Interactive comment on “Structural geology and geophysics as a key to build a hydrogeologic model of granite rock to support a mine” by L. Martinez Landa et al.

SE-2016-27-RC2-Reply: Replies (in colors for clarify) have been added as a supplementary pdf file.

Fig. 1. Figure 9: Results obtained after calibrating the SR4-1 cross-hole test are indicated by a black line, observed data are indicated with circles using a 3D model. All graphs maintain the vertical scale

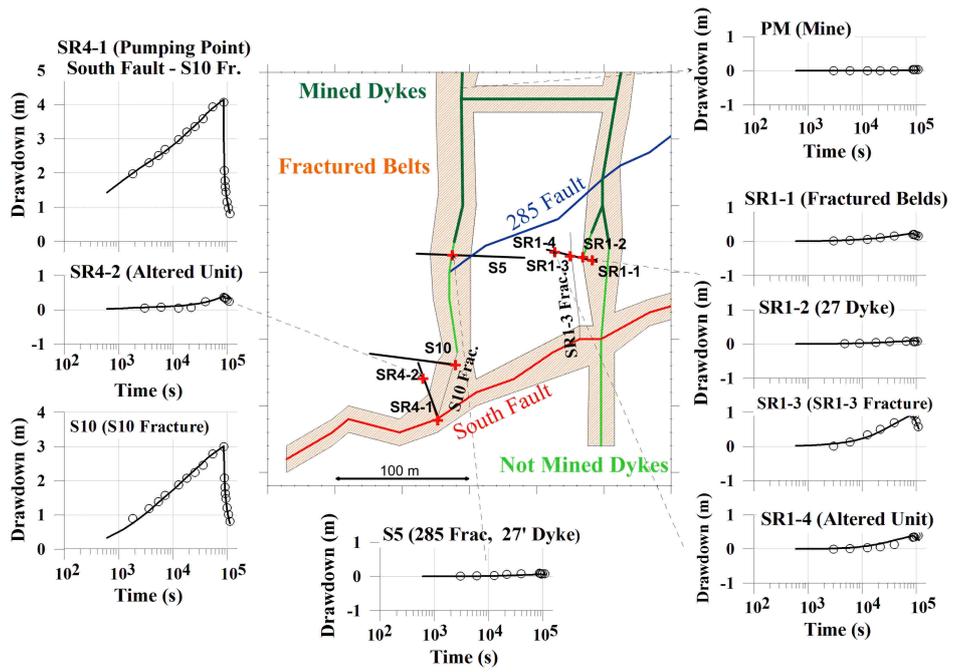
The fractures shown in Figure 11 (blind prediction) appear to be the same as the features shown in Figure 9 (calibration). It has been an error in the Fig 9. We modify the Figure 9 as follows:
